Docket Item #11
BAR CASE# 2005-0082

BAR Meeting
May 4, 2005

ISSUE: New garage/workshop
APPLICANT: Frank Conner
LOCATION: 607 N Columbus Street
ZONE: RB/Residential

Figure 1 East (alley) elevation

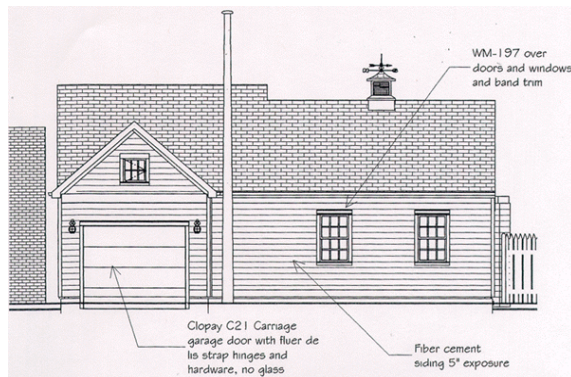
The garage will be clad in fiber cement siding with a 5" exposure and will have a synthetic slate shingle roof. The alley elevation includes a carriage style garage door constructed of steel with a composite overlay. According to the manufacturer information, the door will have a wood grain texture. The door will have decorative fleur de lis hinges and hardware. The door is flanked by two lights. No information has been provided on the proposed light fixtures. A small 6 light casement window will be located above the garage doors. Two six-over-six double hung

windows will also be located on the alley elevation. No information has been provided on the material of the windows. A 26" square cupola will be located on the northern section of the garage. A weathervane will be located on top of the cupola. Specific details on the design of the cupola and weathervane have also not been provided.

Figure 2 West elevation

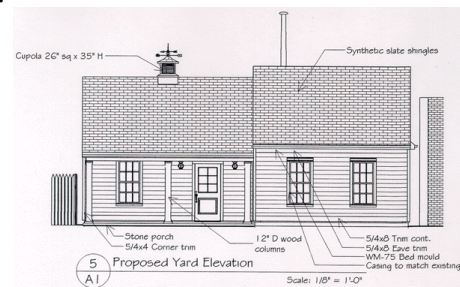
The west elevation of the garage includes three six-over-six windows and a door with six lights. A porch 5' in width and 20' in length will be located on the northern end of this elevation. The porch is supported by three 12" in diameter wood columns. The north elevation of the shed does not

include any variation.
